Reply (in blue) to « RC2: 'Comment on hess-2023-152', Anonymous Referee #2, 18 Sep 2023 (<https://doi.org/10.5194/hess-2023-152-RC2>) » (in italic)

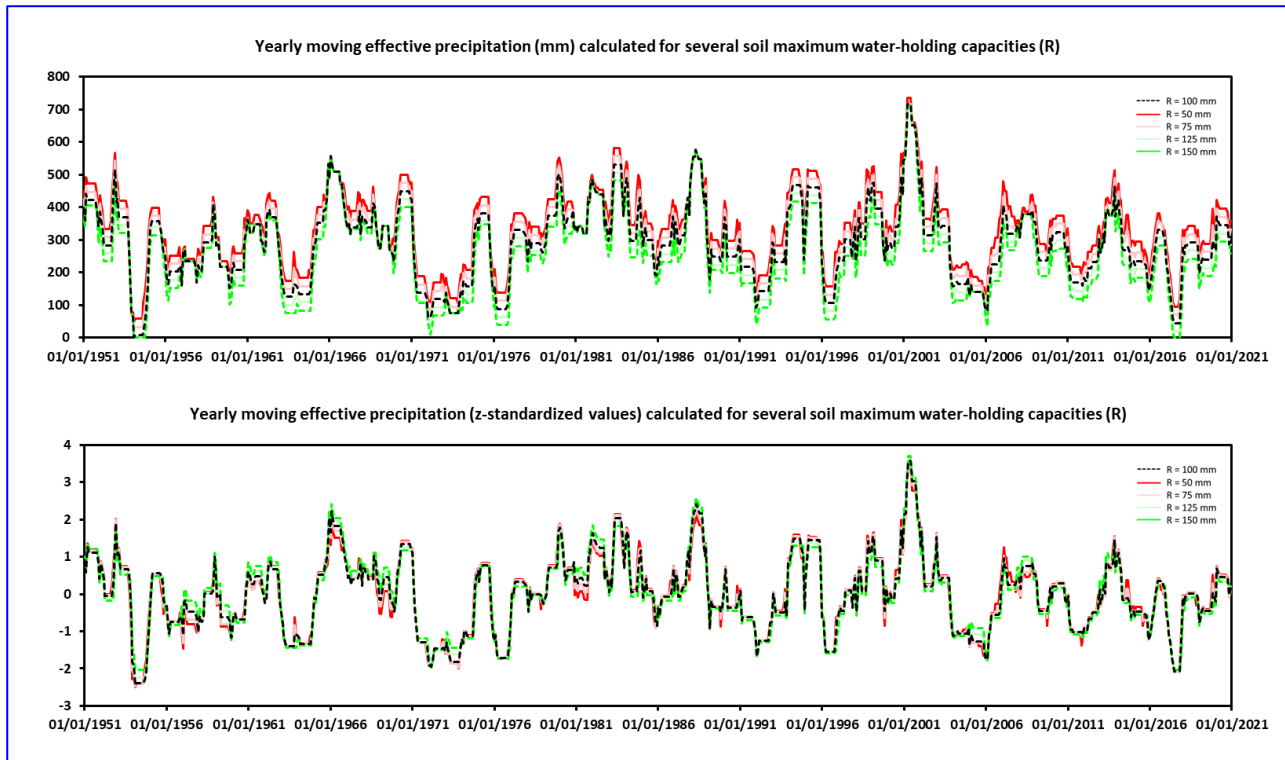
Lines 296-297: this assumption, in my opinion, is unrealistic and makes poorly reliable the use of effective infiltration.

Referee #2 disagrees here with our decision to consider the effective precipitation homogeneous for the entire study area, but without explaining why. As argued, the spatial extension of our study area is relatively restricted. This allows us to assume that the spatial variability of the precipitation input signal is rather small (especially since precipitation is effective mainly in winter, a period during which the spatial variability of precipitation fields is particularly low in comparison to convective summer rainfall event; one can also see the work of Pfister et al. (2017) describing the spatial variability of the precipitation as rather homogeneous over a region otherwise even wider containing our study area). In addition, recharge area mean elevations of the different groups of springs are very close to each other (see Table 1), which makes it possible to consider similar temperatures from one area to another. Perhaps Referee #2 does not agree with our hypothesis because thinking that the soil type/cover variability would induce too much heterogeneity in the effective precipitation input signal. If so, here again we think that our assumption is reasonable. As element of justification, the figure hereafter documents the yearly moving effective precipitation computed for a maximum water-holding capacity varying from 50 to 150 mm (which allows to some extent the soil variability

to be mimicked). It is true that the maximum water-holding capacity value impacts the effective precipitation amount (the smaller the maximum water-holding capacity, the higher the effective precipitation; see the upper panel of the figure), but this does not impact the temporal variability of the signal (see the lower panel of the figure) which is finally the most important for the cross-correlation analysis performed in our study.

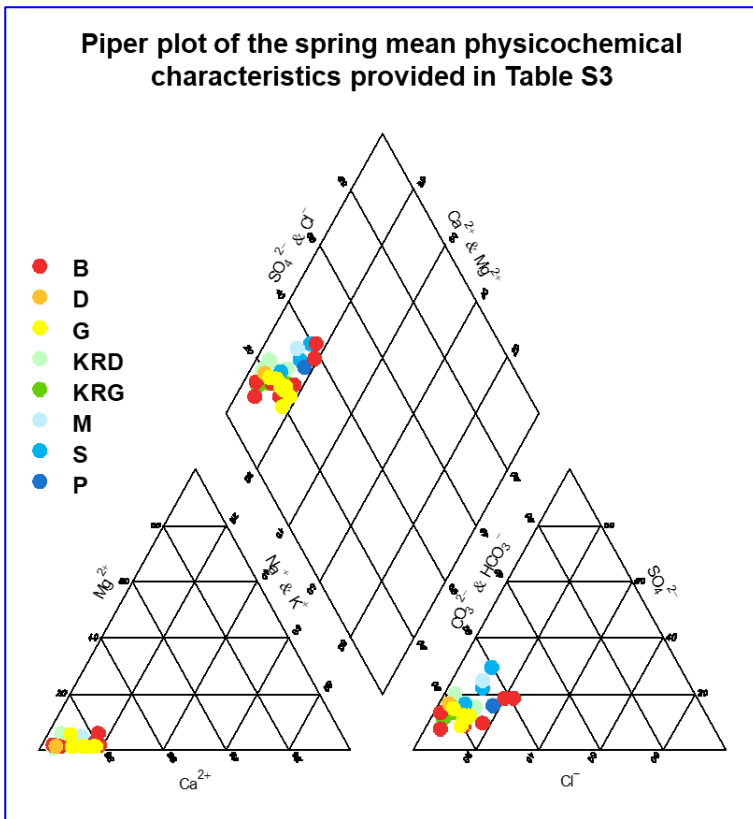
Lines 323-324: might You consider the opportunity of inserting the Piper plots to better visualize and characterize the eventual variability of hydrochemical facies? At line 329 You state that the "... the spatial variability of the hydrochemistry ... is stable over time...", implicitly admitting that this variability do exist and might be clarified by these very simple and traditional plots.

We have already tested the potential added value of a Piper diagram (which allows to distinguish the major types of water based on major ions relative composition), but we concluded that this type of representation would not be the best option for documenting the hydrochemical variability in our study. Indeed, the springs of Luxembourg City, although exhibiting an inter-spring hydrochemical variability, are all characterized with the same CaHCO_3 facies and are therefore represented very close to each other in a Piper plot (see figure hereafter).
